Attachment 1
NRC3-12-0003

Table of RAI Response Dates
(5 pages)

Response to RAI Letter No. 70
(eRAI Tracking No. 6217)

RAI Question No. 02.05.02-17

Figure 1: Comparison of mean of response spectra (5 percent damping) for weakly matched time histories to the target DE spectra for the 10^{-3} high frequency (HF) motions

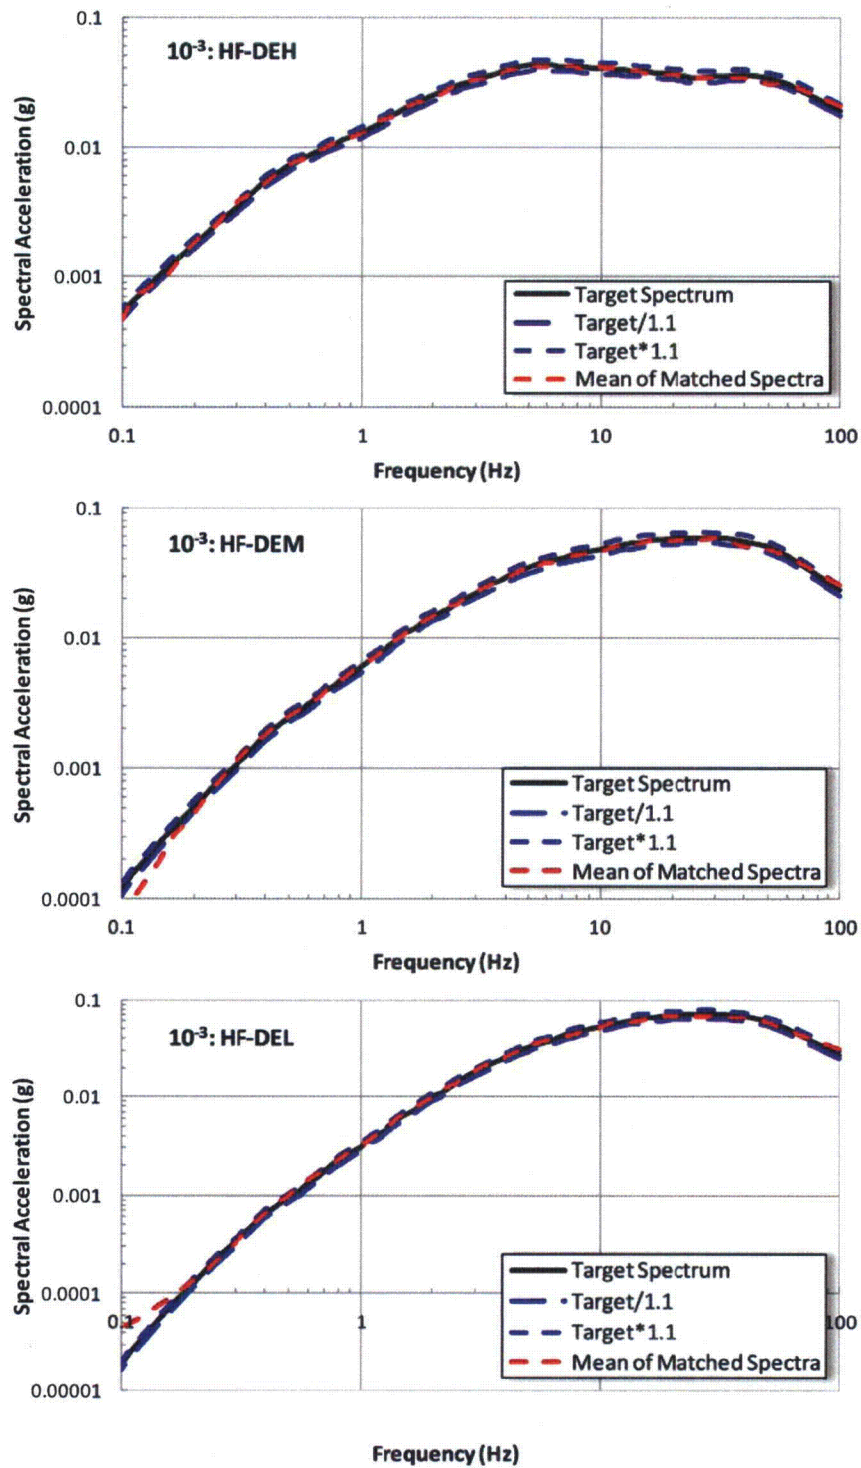
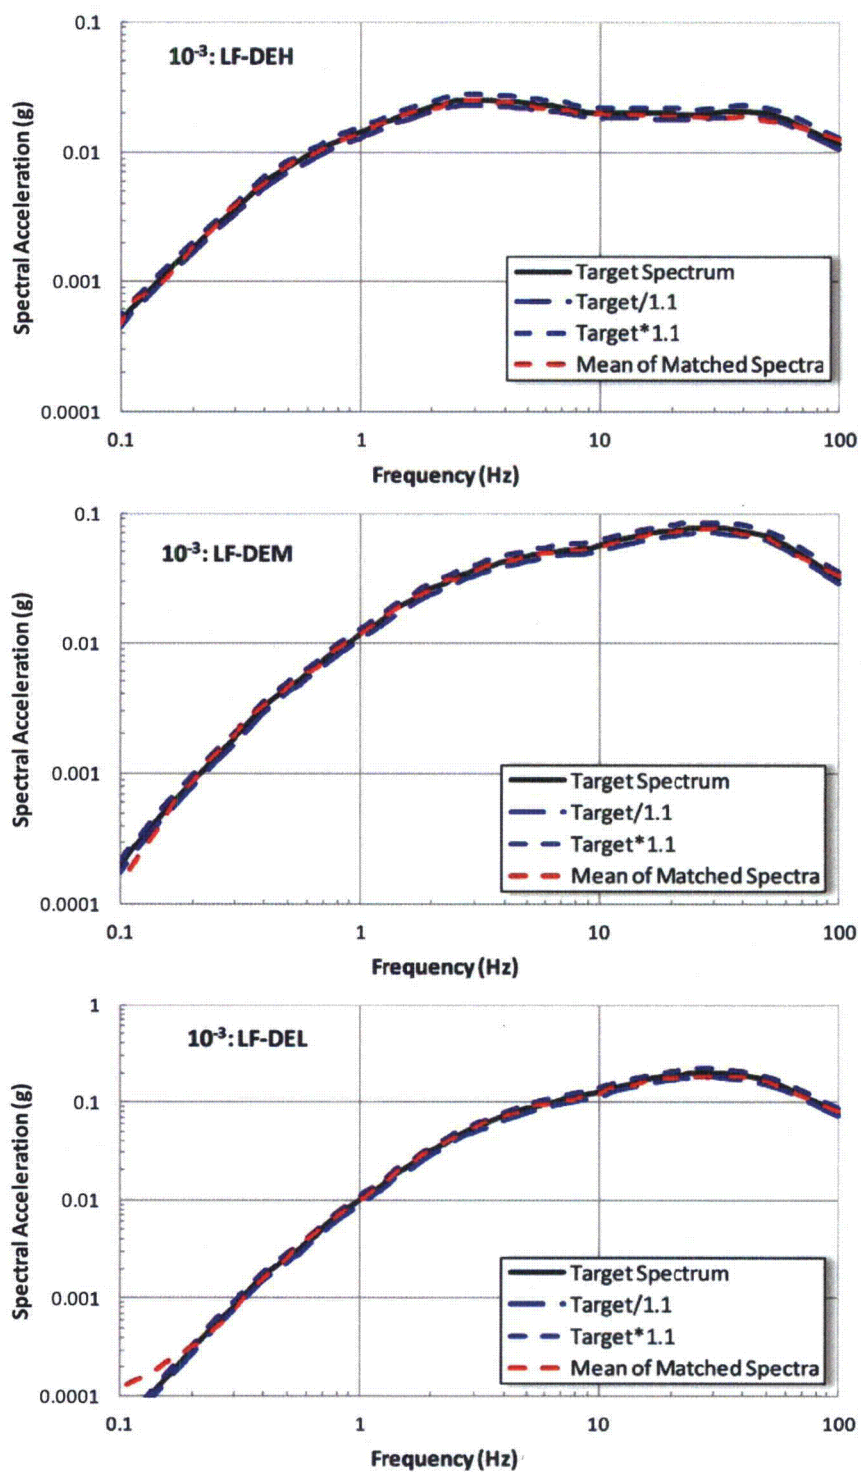
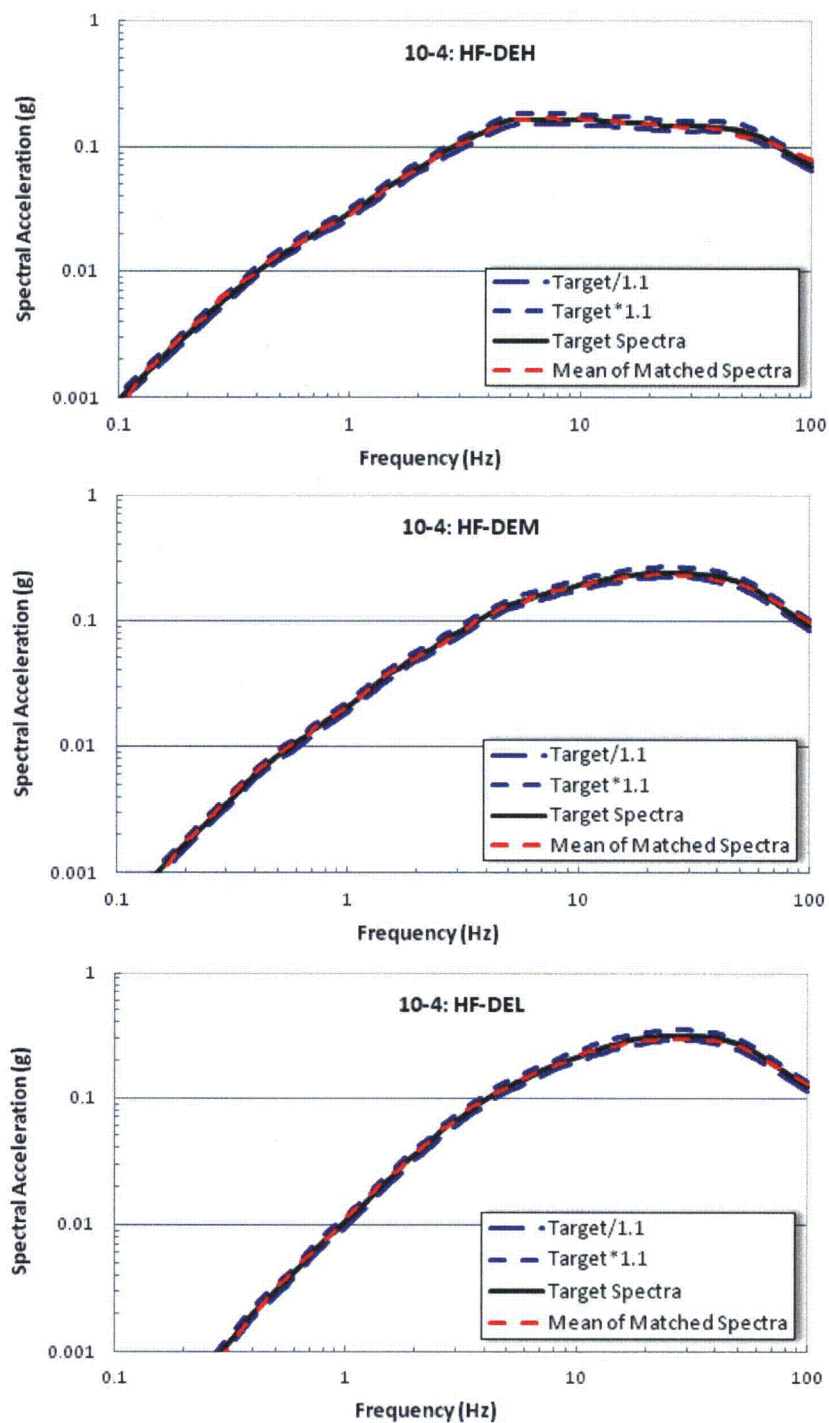
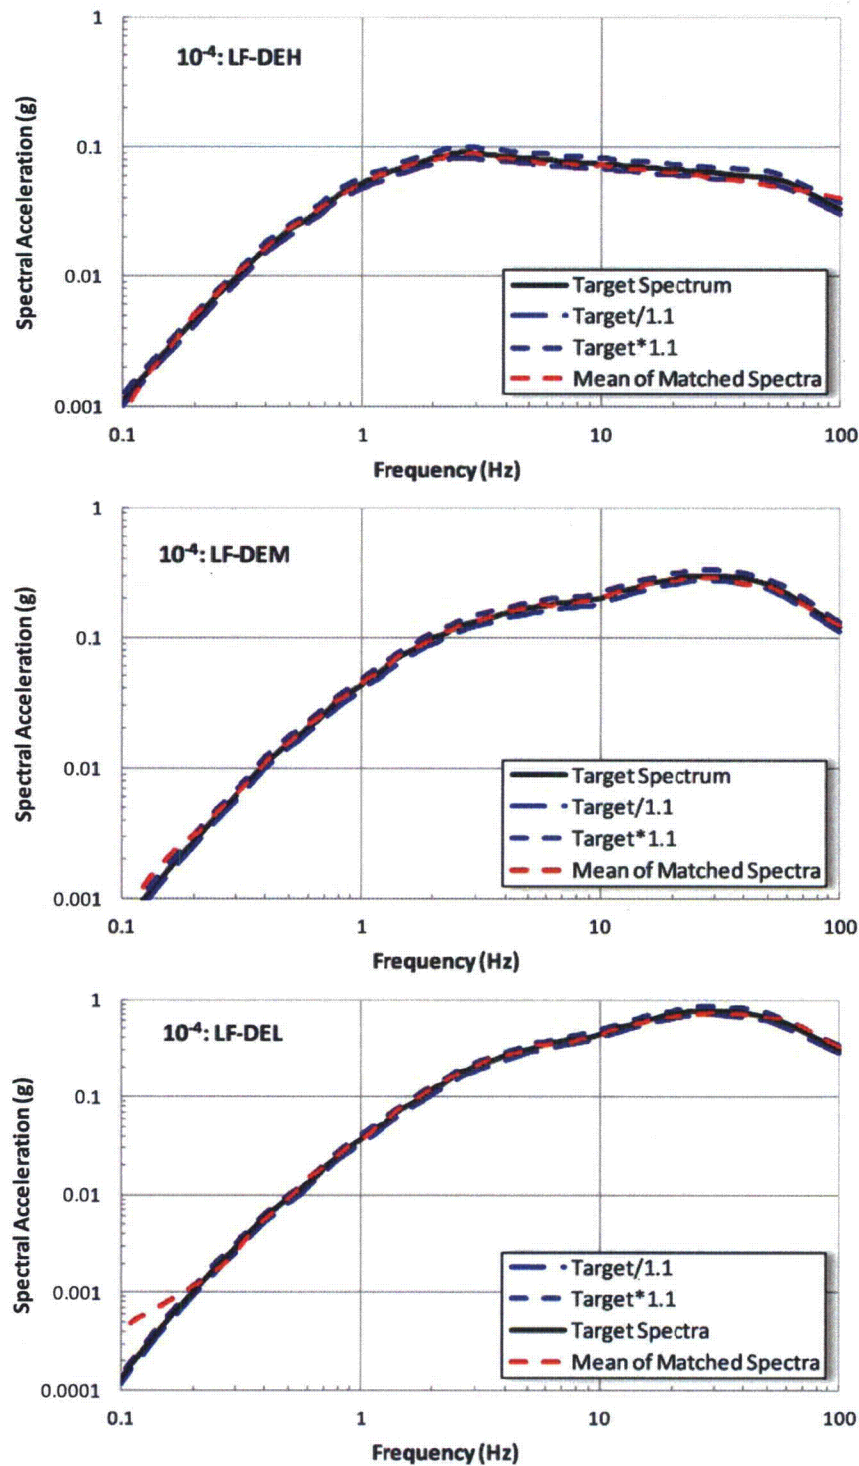
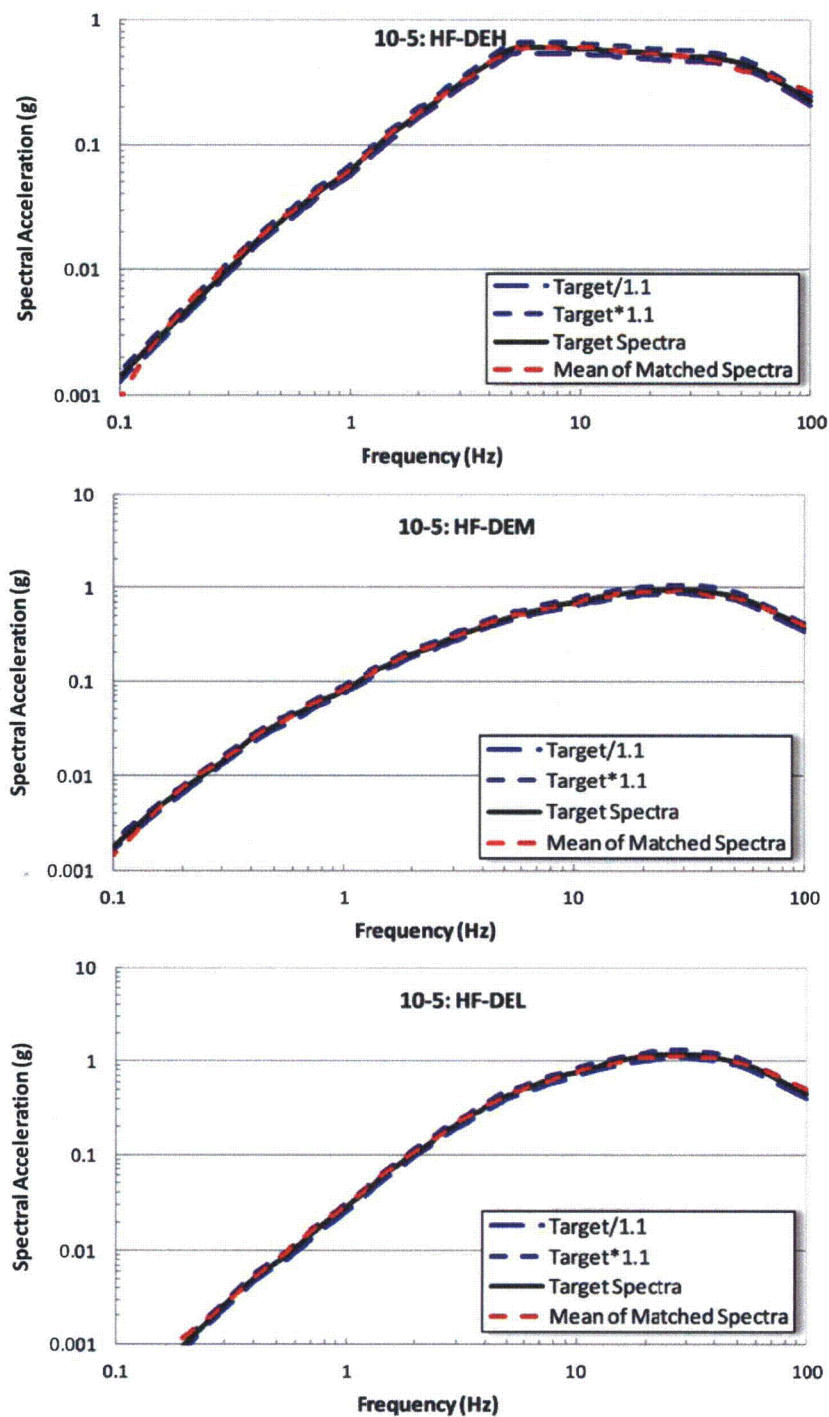
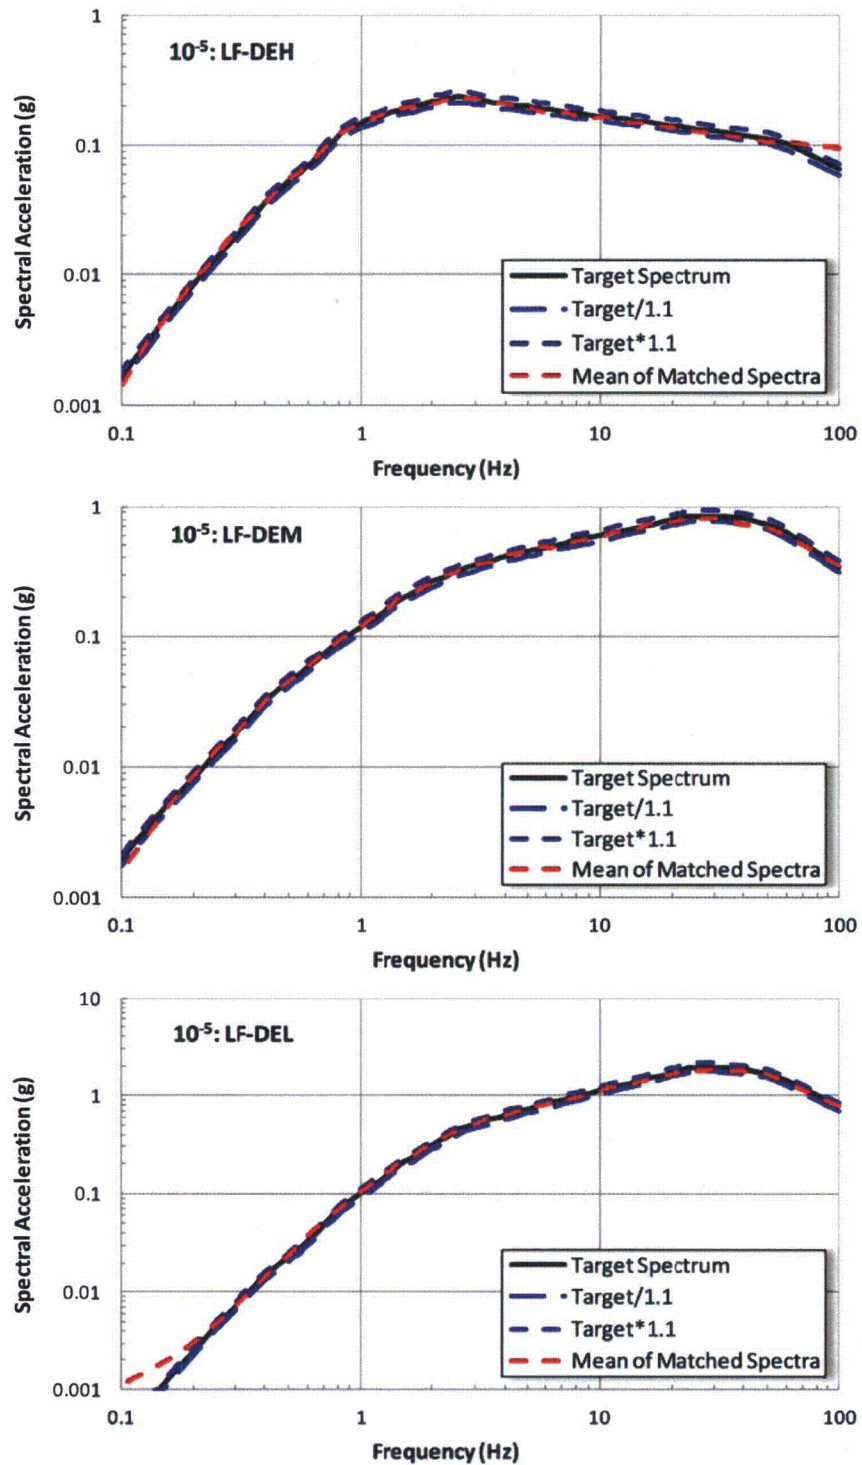
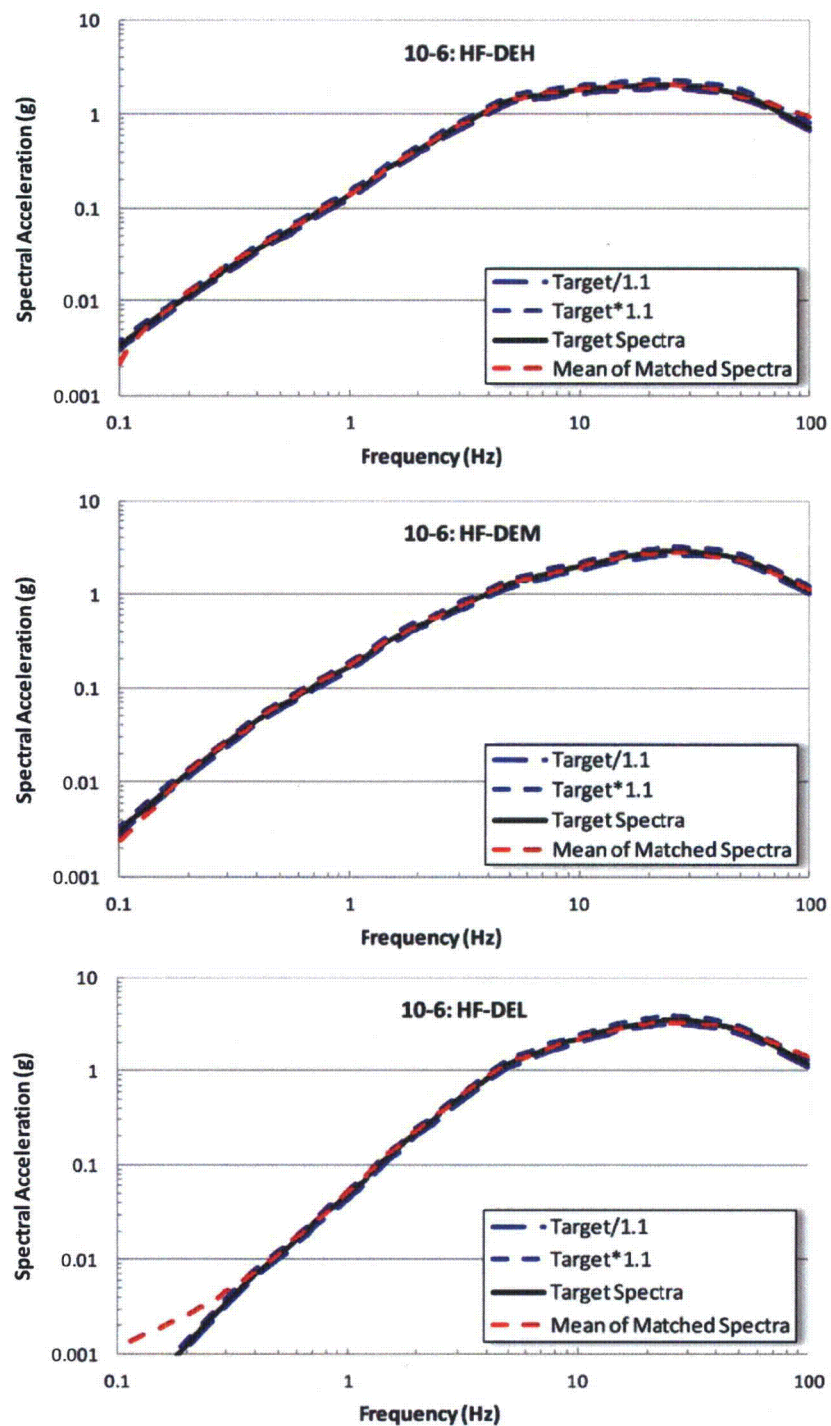
FSAR Section 2.5.2.5.2 indicates that the selected time histories were scaled to approximately match the target DE spectrum using a limited number of iterations of the program RASCALS. Please provide more detail regarding the scaling process. In addition, please quantitatively compare the mean response spectrum of each suite of scaled time histories to the respective target spectrum.

DE target response spectra were developed to represent the contributions to the Fermi 3 site hazard for high frequency (HF) and low frequency (LF) ground motions. DE spectra were developed for hazard levels corresponding to 10^{-3} , 10^{-4} , 10^{-5} , and 10^{-6} mean annual frequencies of exceedance. The target magnitudes and distances for each DE are listed in FSAR Table 2.5.2-219. For each case, three DE spectra are defined: a high magnitude target, DEH; an intermediate magnitude target, DEM; and a low magnitude target, DEL. As described in FSAR Subsection 2.5.2.5.2, the 30 time histories in the appropriate magnitude and distance bin of the central and eastern United States (CEUS) time history database in NUREG/CR-6728 (McGuire et al., 2001) were weakly matched to each DE spectrum. Figures 1 through 8 compare the target DE spectra to the mean response spectra for the 30 scaled time histories for HF and LF motions at the four hazard levels. Each plot also shows the target DE spectrum multiplied by 1.1 and divided by 1.1 to provide a sense of the accuracy of the average fit.

The comparisons shown on Figures 1 through 8 show that the means of the response spectral ordinates for the scaled time histories are generally within a factor of 1.1 of the target DE response spectrum. All spectra shown on the figures are for 5 percent damping. In some cases, large deviations from the target spectrum occur at frequencies below about 0.2 Hz. Because the fundamental frequencies of the site profiles are approximately 3 Hz, the deviations at very low frequencies have little impact, as indicated by the amplification factors near unity for frequencies less than 1 Hz (e.g., FSAR Figure 2.5.2-270). In a few cases for the LF DE spectra (LF DEH for 10^{-5} and 10^{-6}), large deviations from the target spectrum occur at frequencies above 50 Hz. These deviations are not significant because the motions in this frequency range are not used to define the LF site amplification factors.

The results shown on Figures 1 through 8 indicate that the mean of the response spectra for the weakly scaled time histories provide a good representation of the DE target response spectra.
